City of Portland, Maine - Building or Use Permit Application

Job No: 2011-08-2037-SF	Date Applied: 8/18/2011	CBL: 406 - - F - 060 - 001 - - - - -	
Location of Construction: 4 STEPPING STONE - Lot 10	Owner Name: King Construction	Owner Address: 6198 Saco Ave. Old Orchard Beach, ME 04064	Phone:
Business Name:	Contractor Name: Thomas Blackburn	Contractor Address: 14 Hanover St., Portland, ME 04101	Phone: 207-232-8134
Lessee/Buyer's Name:	Phone:	Permit Type: Building - New Single Family	Zone: R-3
Past Use: Vacant Land	Proposed Use: New Single family - construct a new, two story (28' x 34'), single family home with 12' x 22' one story attached garage	Cost of Work: 115000.00	CEO District:
		Fire Dept: <input checked="" type="checkbox"/> Approved <i>w/ conditions</i> <input type="checkbox"/> Denied <input type="checkbox"/> N/A	Inspection: Use Group: <i>RS</i> Type: <i>SB</i> <i>MUBEC</i>
Proposed Project Description: New single family home - 28' x 34' w/12' x 22' attached garage		Signature: <i>Capt. Perrone 11/8/11</i> Pedestrian Activities District (P.A.D.)

RE: C. of O. for # 4 Stepping Stone, King Construction Single Family Home
(Id#2011-08-2037-SF) (CBL 406 F 060001)

FIRST FLOOR FRAMING PLAN

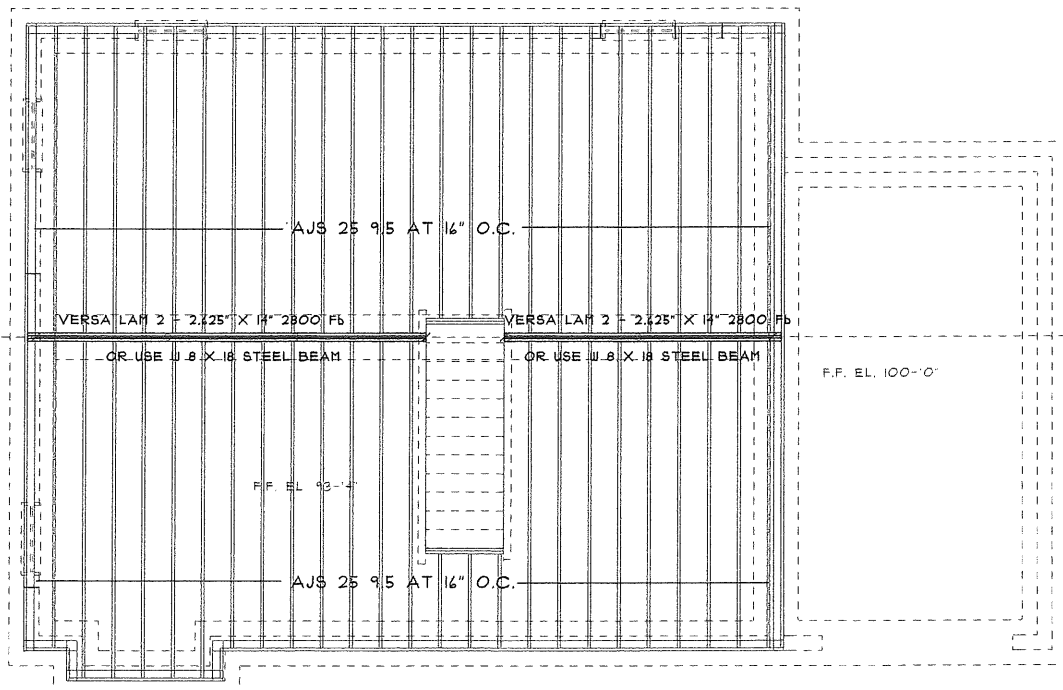
- ✓ Hangers at window seat joists
- Nails in floor joists at beam
- ✓ Framing not per plan. TJIs spec solid sawn lumber installed (Floor framing at steps to garage)
- Fire block soffit
- Drywall under stairs to garage (consulted with the Director)
- Lateral and vertical attachment at deck
- ✓ Lally columns in basement or revised plans
- ✓ Access to attic above garage
- Protect/repair foundation insulation"

SECTION 1 TYPICAL FROST WALL AT GARAGE
 SCALE: 1/2" = 1'-0"

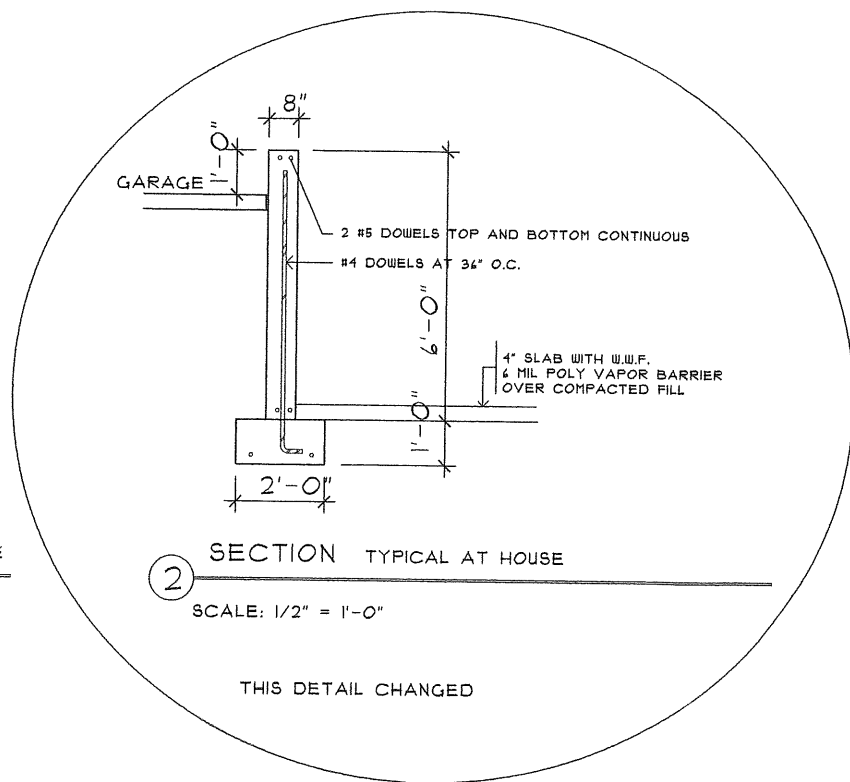
THIS DETAIL CHANGED
